VILLAGE OF CALDWELL
NOBLE COUNTY, OHIO
PRISON PUMP STATION

ADDENDUM #2

JULY 9, 2026

THRASHER PROJECT #T20-11309

SHEET LAYOUT

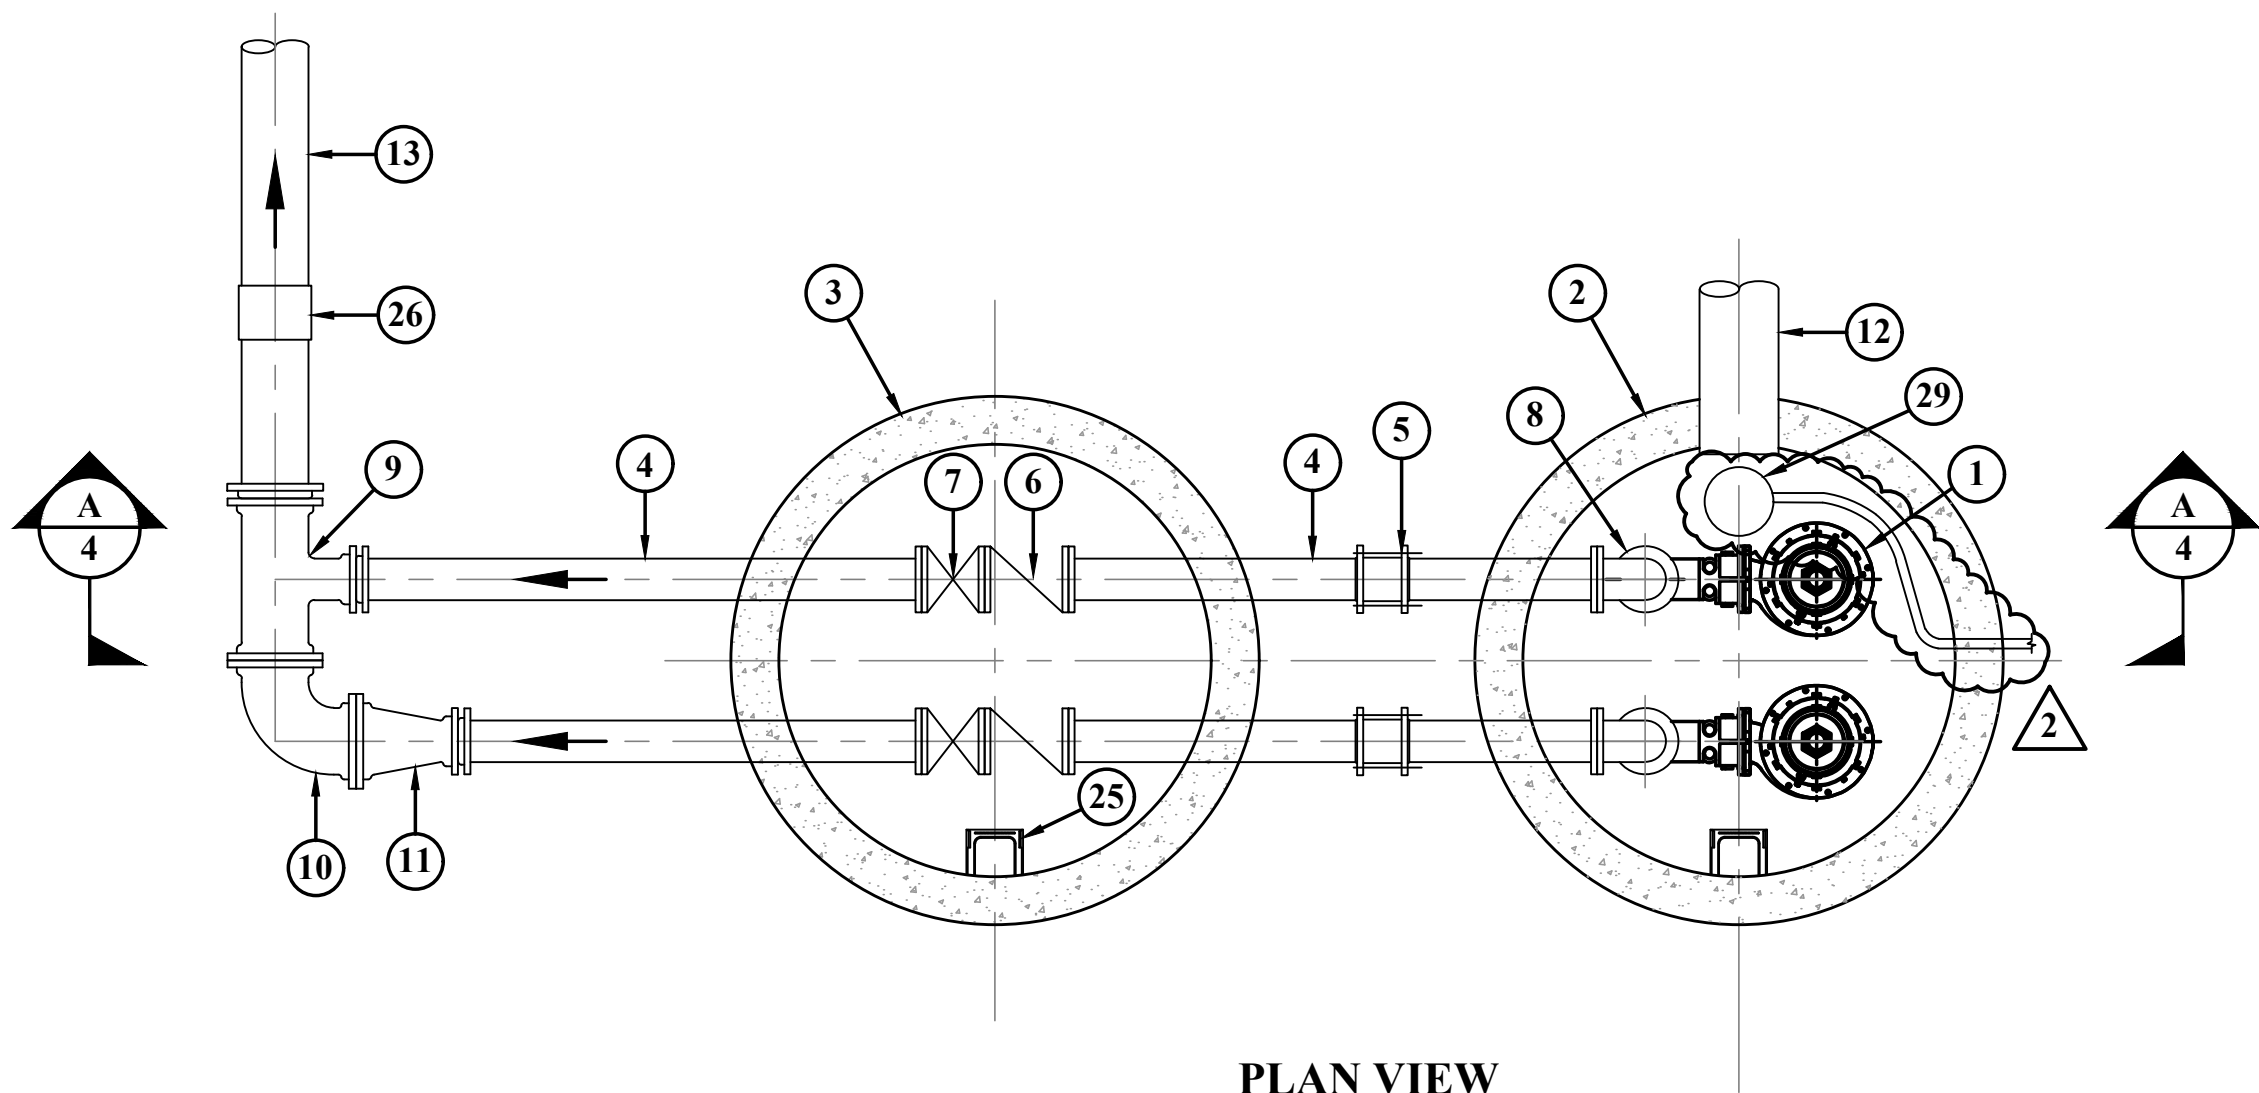
Bid item 8 is an additional bar screen, and it is not shown in the plans. Can you please provide drawing and details for the installation of this item?

CONTRACTOR SHALL REMOVE EXISTING BAR SCREEN IN ITS ENTIRETY AND FURNISH AND INSTALL NEW BAR SCREEN COMPLETE AND OPERATIONAL. CONTRACTOR IS RESPONSIBLE FOR ALL ELECTRICAL (DISCONNECTION, REMOVAL, AND NEW POWER/CONTROL WIRING AND CONDUIT), PIPING MODIFICATIONS, SUPPORTS, ANCHORS, AND CHANNEL OR STRUCTURAL MANIPULATIONS REQUIRED FOR INSTALLATION, WHETHER OR NOT SHOWN ON THE DRAWINGS. CONTRACTOR SHALL MAINTAIN FLOW THROUGH THE FACILITY AT ALL TIMES DURING CONSTRUCTION AT NO ADDITIONAL COST TO THE OWNER

The bid item will be added to the plans revised by this addendum to show equipment location and installation details. The details for installation with this bid item fall under section 443140.

VILLAGE OF CALDWELL NOBLE COUNTY, OHIO PRISON PUMP STATION	SHEET No. 4
PUMP STATION PLAN & SECTION

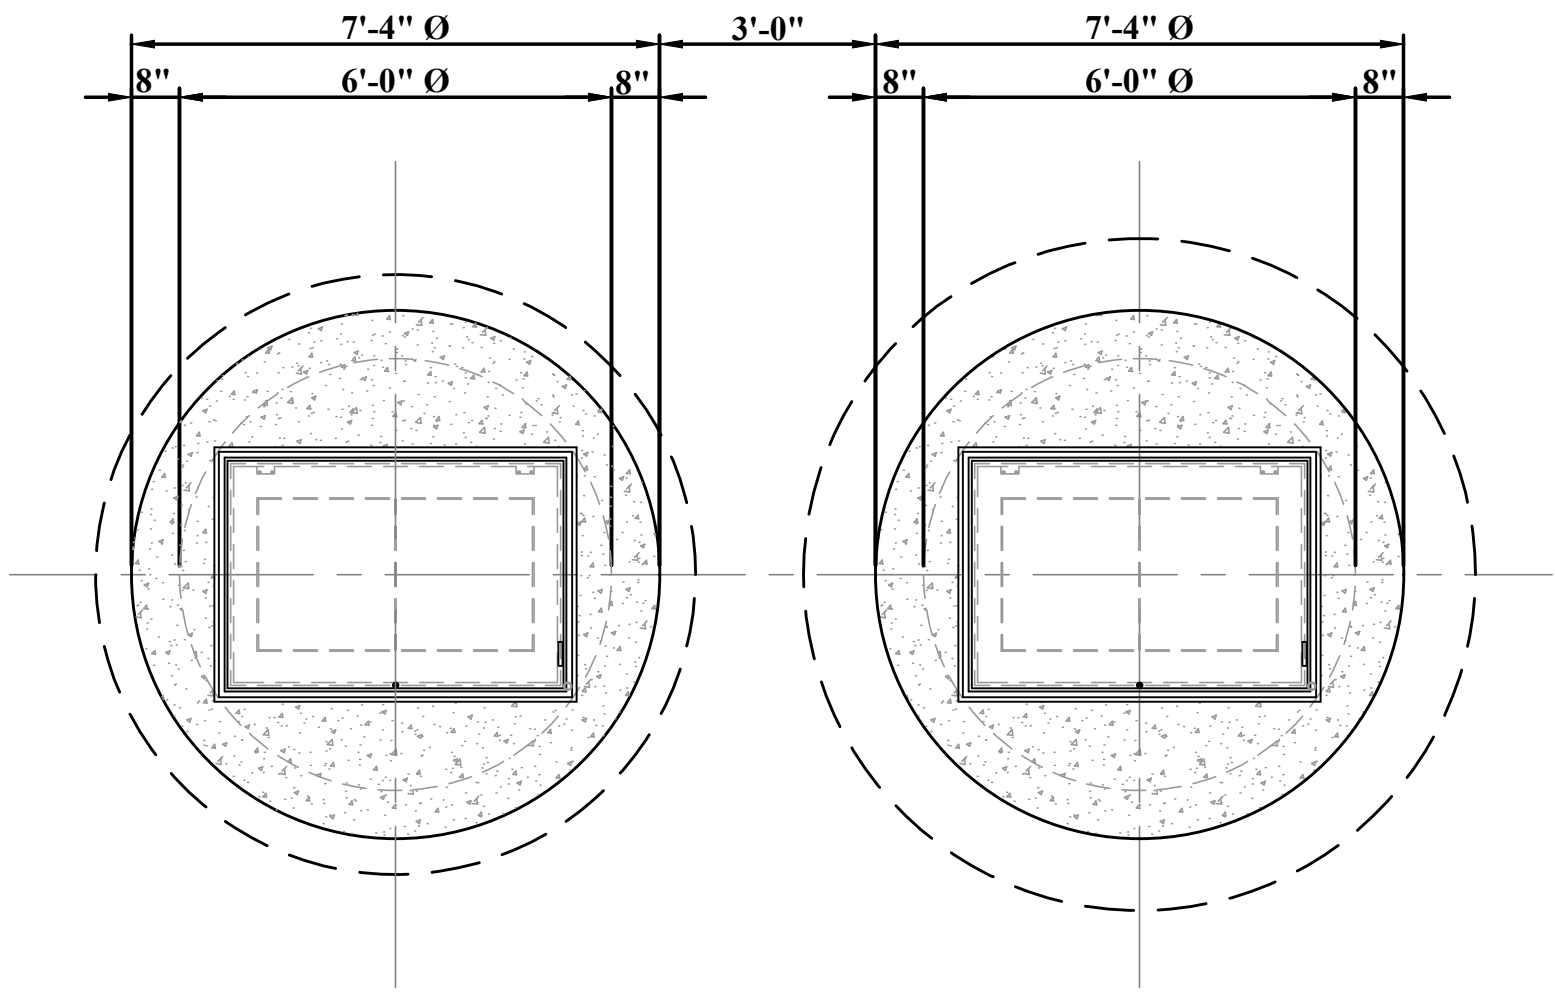
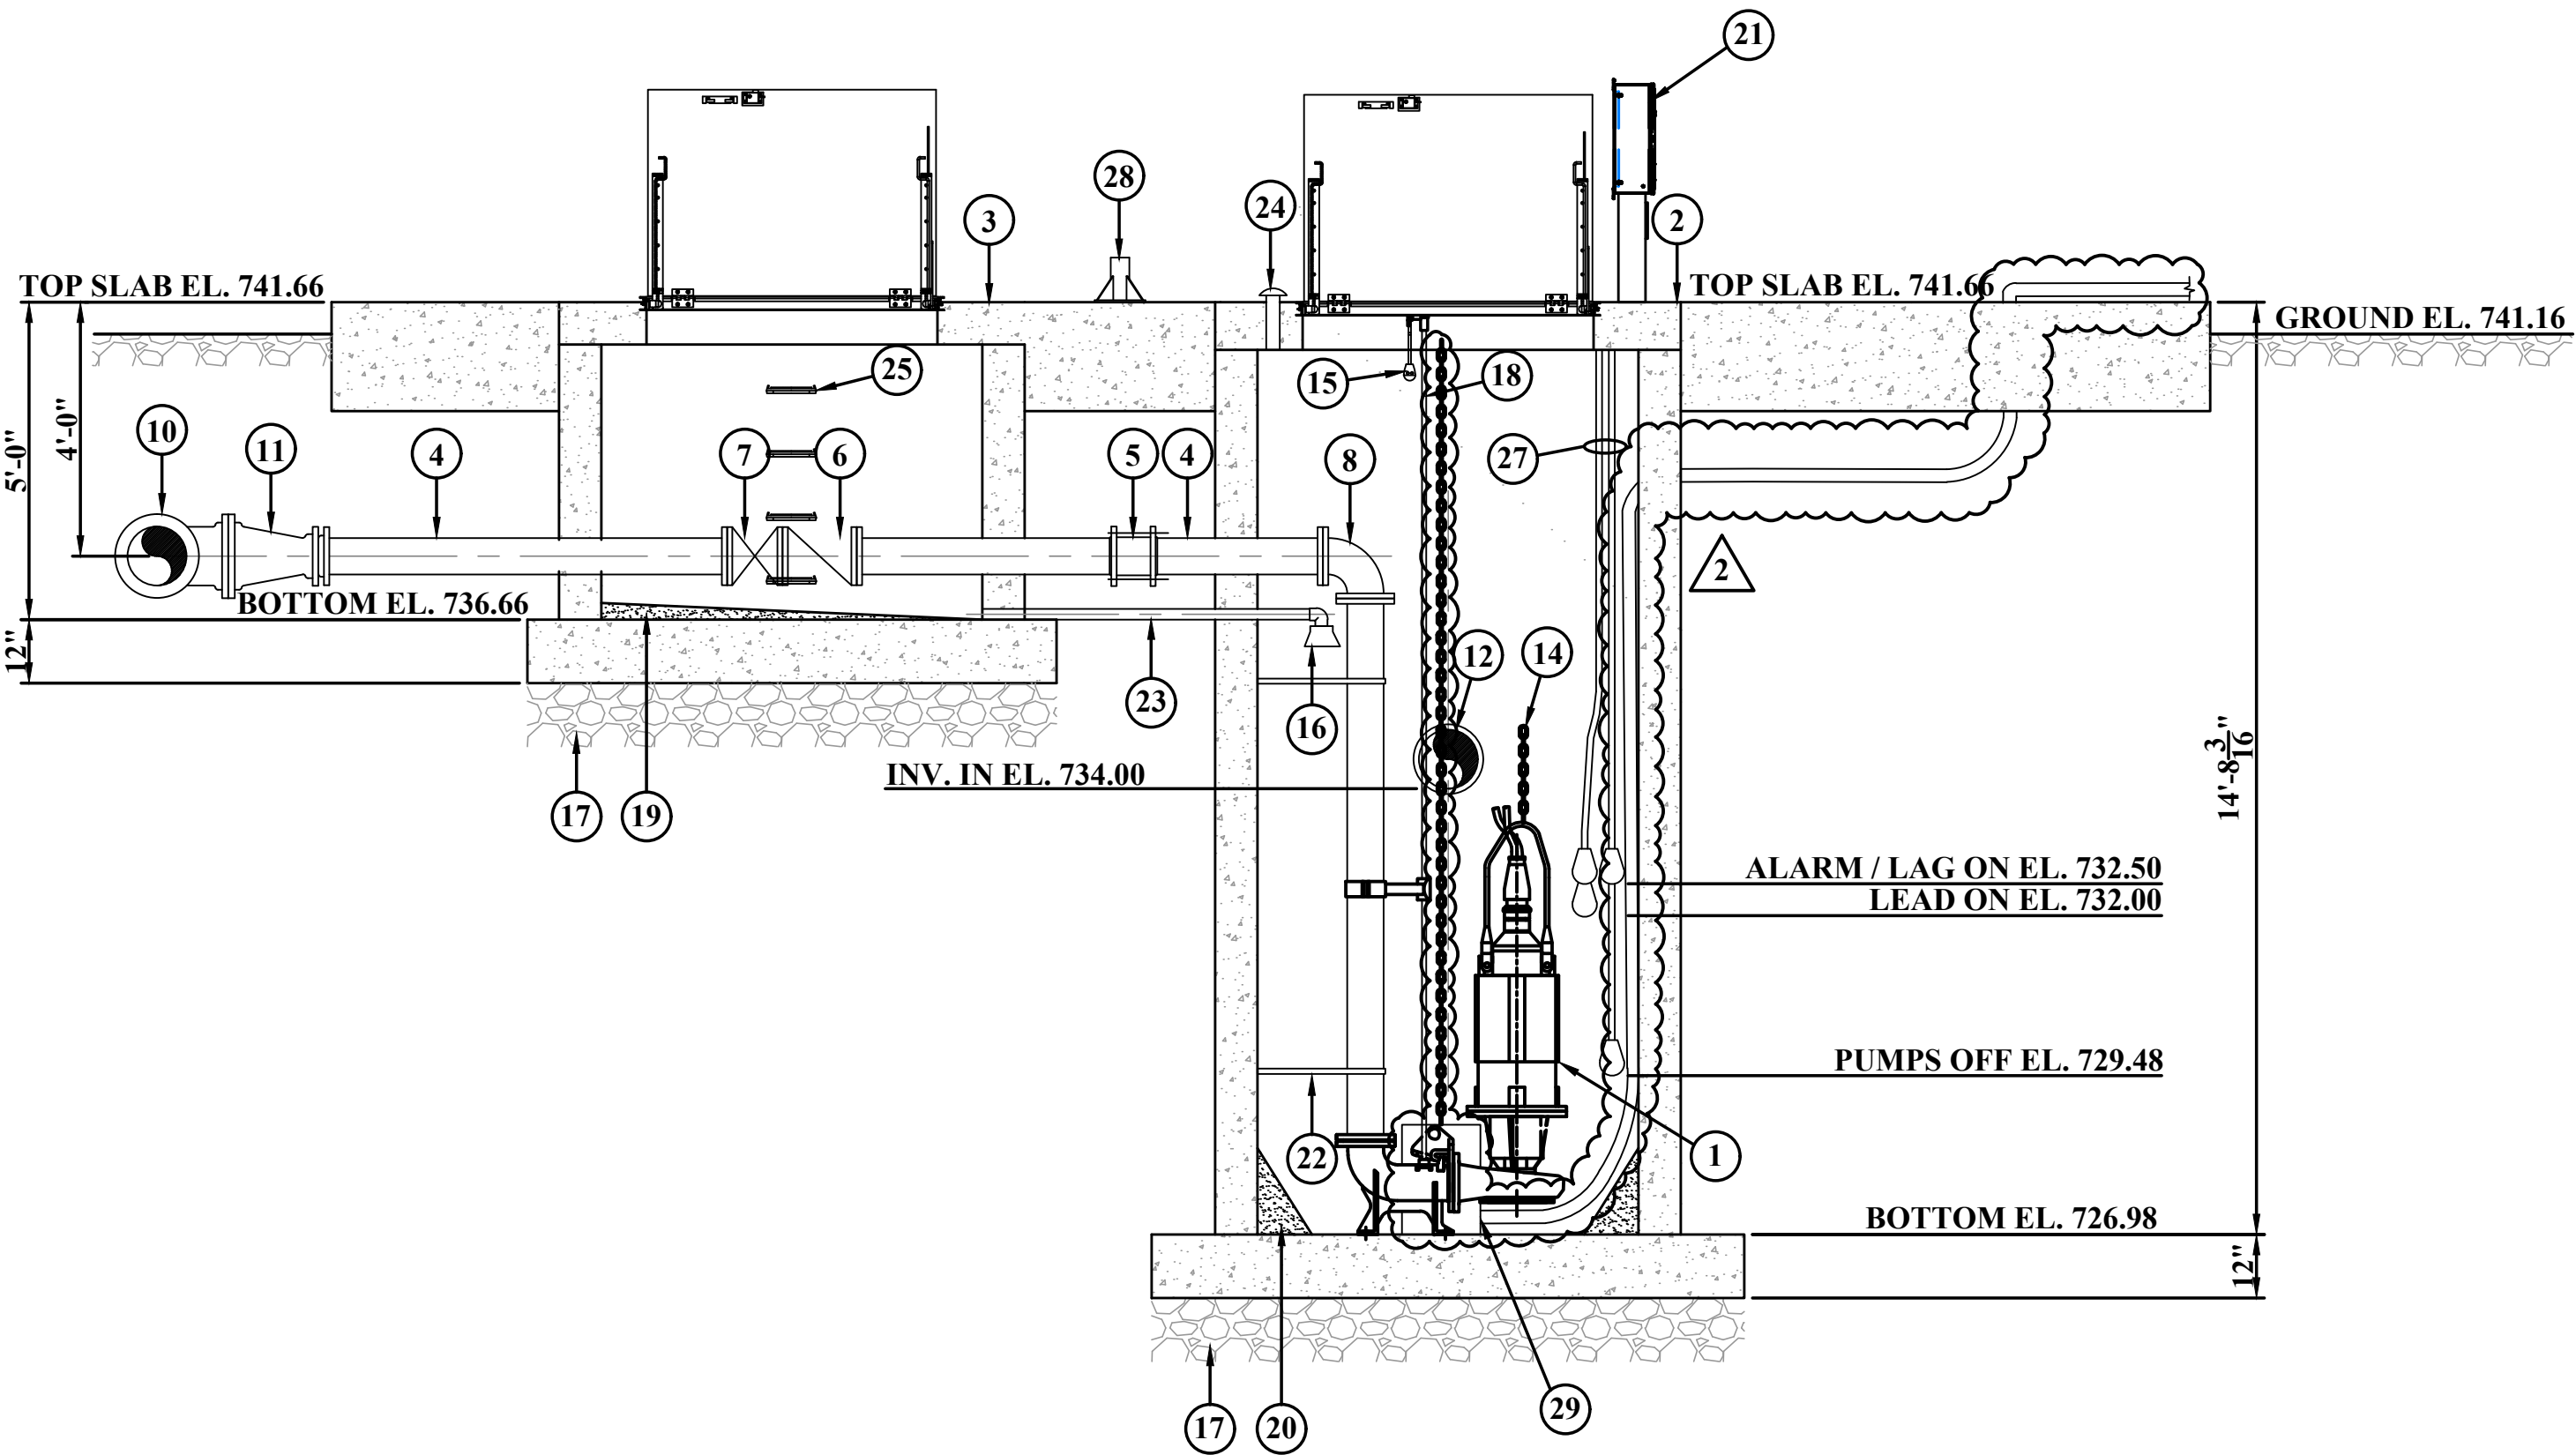
Bid item 7 is aeration for the wet well and there is a spec section for it, but it is not shown on the wet well drawing on Sheet 4 or listed in the key notes with all the other materials and equipment. Can you please provide more information on what is installed in the wet well?

2	SWB	07/08/26	ADDENDUM No.2-ADDED FOG BUSTER	
NO.	BY	DATE	DESCRIPTION

The wet well aeration equipment is a FOG Buster air-powered circulation system by OTC Industrial Technologies (or pre-approved equal), per Spec Section 435510, Bid Item 7. Drawing Sheet 4 and the key notes have been revised by this Addendum to show the equipment location and installation.

- ㉖ D.I. TO PVC TRANSITION.
- ㉗ PUMP LEVEL SYSTEM.
- ㉘ HOIST SOCKET.
- ㉙ FOG BUSTER W/ SS LIFTING CHAIN & AIR HOSE WITHIN 2" CONDUIT.
